From: Amanda Scholes on behalf of Planning.Responses
Sent: 30 November 2021 09:30
To: Planning Scanning
Subject: FW: Dappers Lane - Drainage- OWC application
Attachments: LDC-ARUN-2021-017 1c OWC Approval letter (1).pdf; LDC-ARUN-2021-017 1c OWC Consent.pdf; A360 - 09 C Offsite Drainage Works.pdf

RE: Land Drainage Works – Development at junction of Water Lane & Dappers Lane, Angmering

**Connection to existing ditch & culvert improvements, at development at
junction of Water Lane & Dappers Lane, Angmering**

Scale	Date	Drawn	Checked
250 @ A1	Nov 2021	HR	JS
Drawing No.	A360 - 09	Revision	C

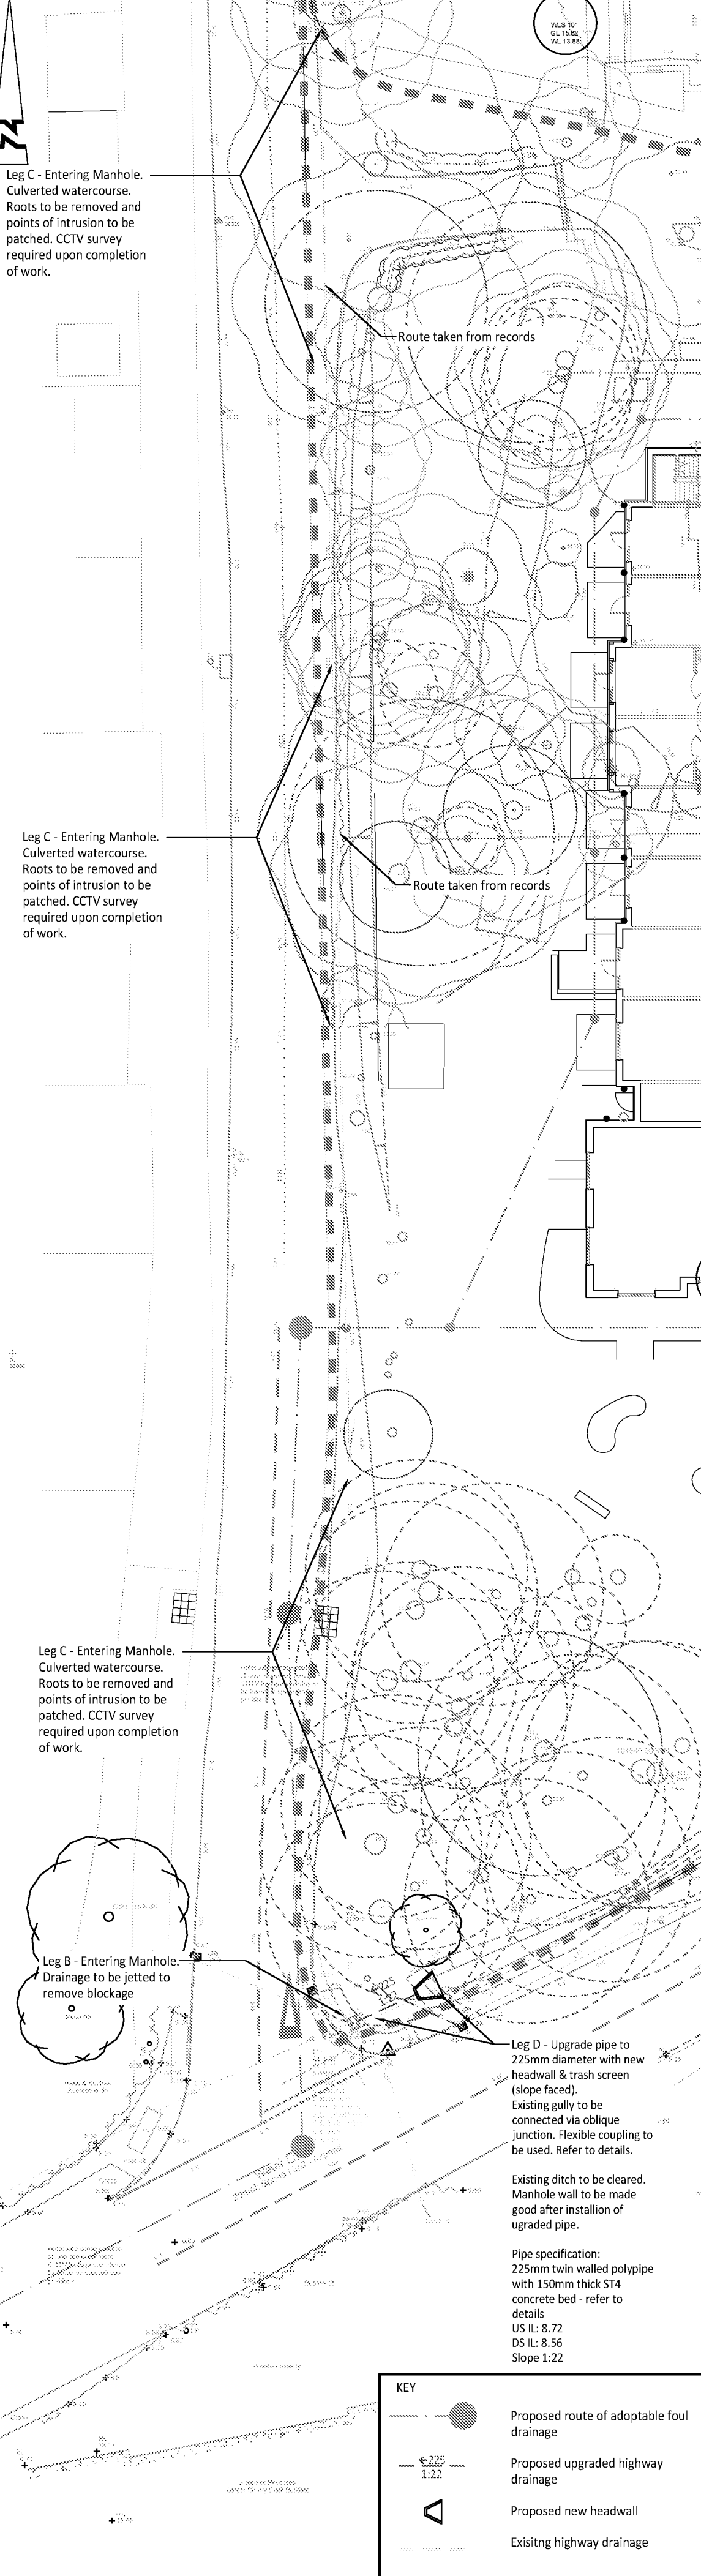
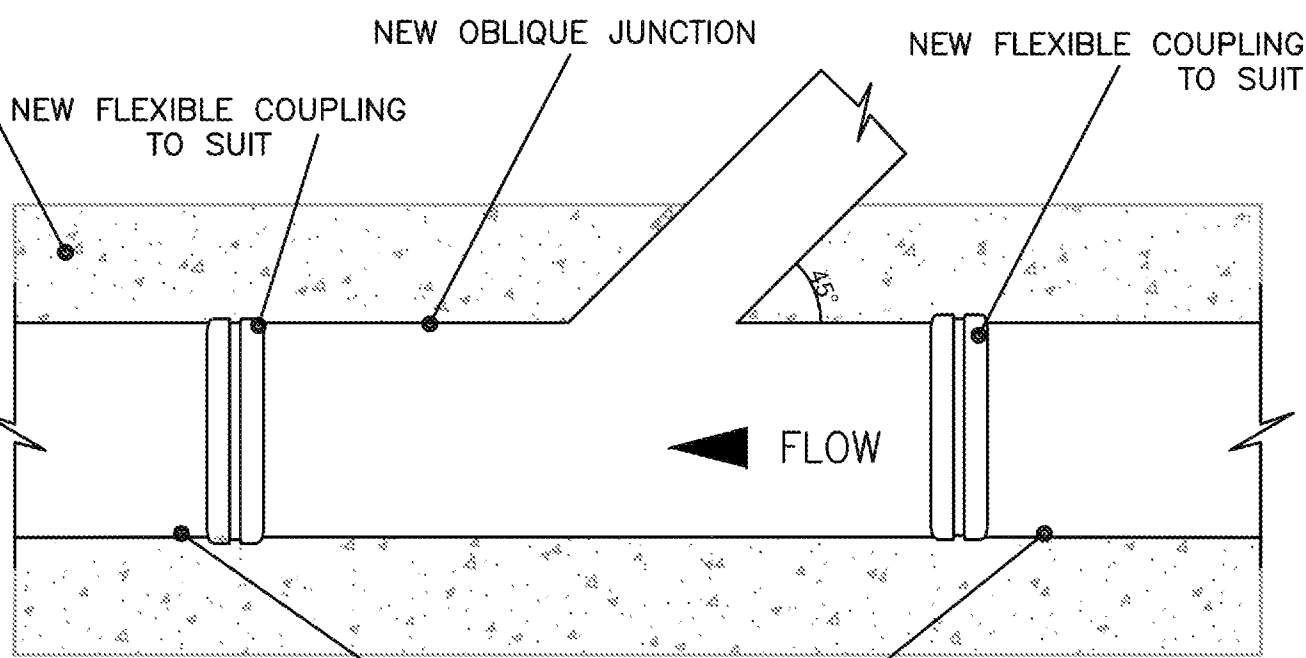
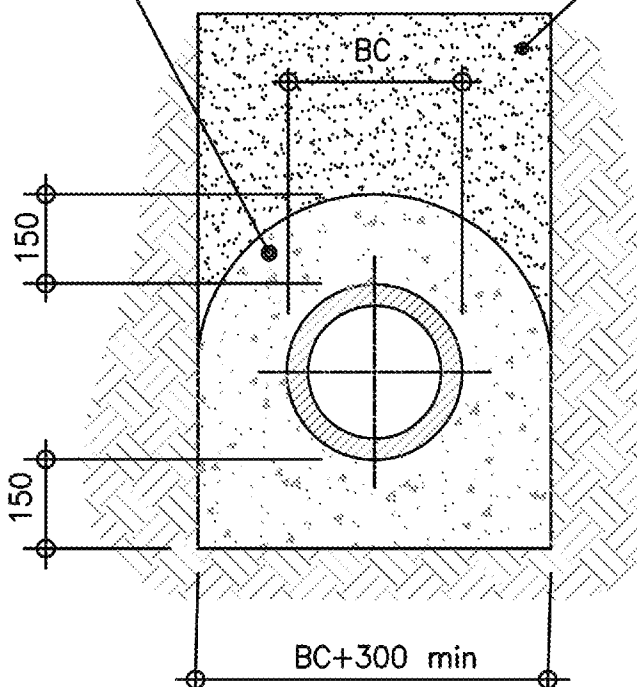
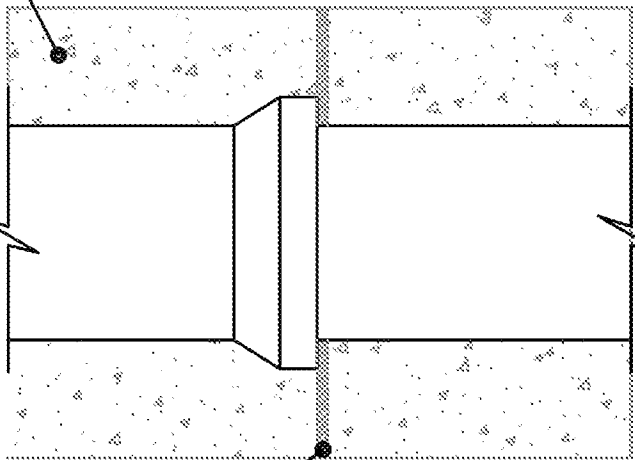
3. Please could you colour the culverts/ditch on the offsite drainage works plan to make them clearer. ok
4. Proposed headwall & Leg 'D';
 - a) Specify invert levels of proposed 225mm pipe. ok

- b) Brickwork refers to note 3 but should be note 2. Prefabricated headwall now specified as discussed. Specify the manufacturer and model, to suit the 225mm pipe.

- c) Show how the post & rail fence will be bolted to the headwall. Prefabricated hand railing now specified. ok
 - d) Please adjust the proposed trash screen design to utilise this one or very similar; 225mm Sloped Trash Screen with Sides 45 degrees | Althon Specify the 45 degree trash screen in association with 4b)

- e) Entry into existing manhole – make good manhole wall as necessary – add note. ok
 - f) All pipework to be twin walled polypipe or similar approved with 150mm thick ST4 concrete bed and surround with expansion joints. Add suitable note/detail. See enclosed drawing to assist.

5. Gully connection – existing lateral to be joined to new pipework/oblique junction using a 'flexible' coupling – add note. Remove the saddle connection detail as this is not applicable.

6. Leg 'B' - proposals noted thank you. -
7. Leg 'C' – proposals noted but ensure entire length of culvert adjacent the site boundary is shown. ok
8. Leg 'X' - Undertake further CCTV survey to enable completion of previous survey to Black Ditch – Present findings so further discussions can be had. Relevant notes added to plan. ok

9. Note 'Connection to be remade to upgraded pipeline between MH1 and ditch' shown in wrong location. ok

Leg X - Remove roots and patch line points of intrusion. Existing manhole to be uncovered and cover to be raised to existing ground level. All blockages between proposed site and Black Ditch to be cleared & CCTV survey to be completed as soon as possible and prior to any live connection of proposed site drainage.
